SERVICE LETTER 185

10000 Nutplate Installation

Aircraft Makes/Model(s):	Float Model(s):	Compliance: Optional	By: MAS
AT-802 AT-802A	10000A	Part Number: 1009886 Date: 1/15/2025	Approved: DRH Revision: D

Nutplate Strip

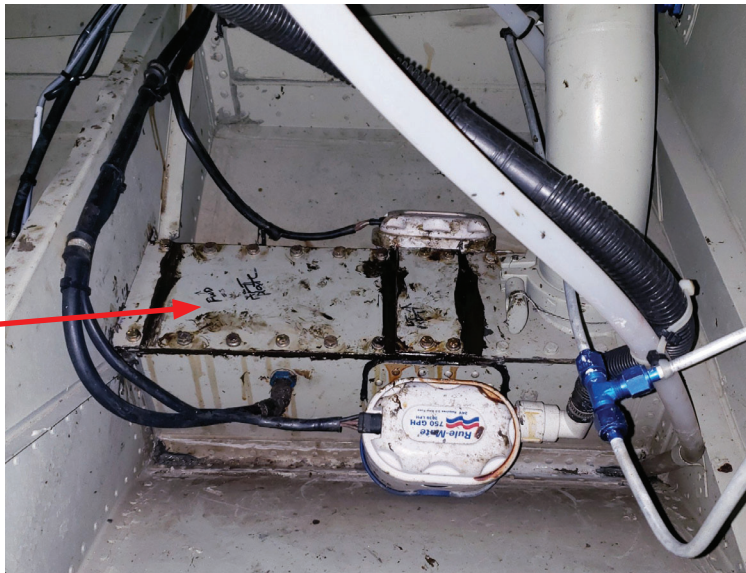
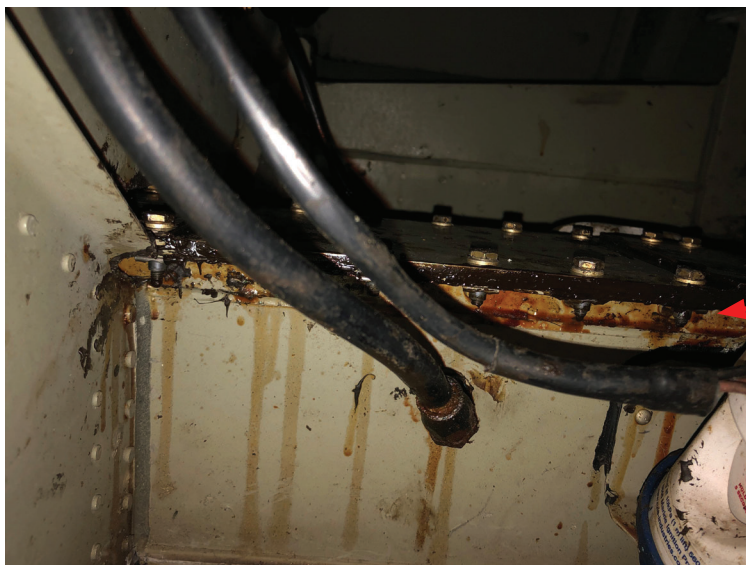
Traditionally, the scoop tunnel on the Air Tractor uses nuts, washers, and bolts. Due to tight quarters, it is difficult to access when performing maintenance. This service letter provides a nutplate strip installation for easier maintenance in the future.

1. Access scoop tunnel through aft panel in foam/baggage compartment.
2. Remove hardware and covers on top of scoop tunnel.
3. Discard hardware (nuts and washers) on bottom of scoop tunnel flange.
4. Clean sealant from covers and top and bottom of flanges.
5. Reinstall covers with PR-1422 or equivalent using nutplate strips on bottom and existing bolts and washers.
 - 5.1. Alternate: reinstall covers using scoop tunnel seal replacement work instructions contained in Service Letter 268.
6. Leak check scoop tunnels.
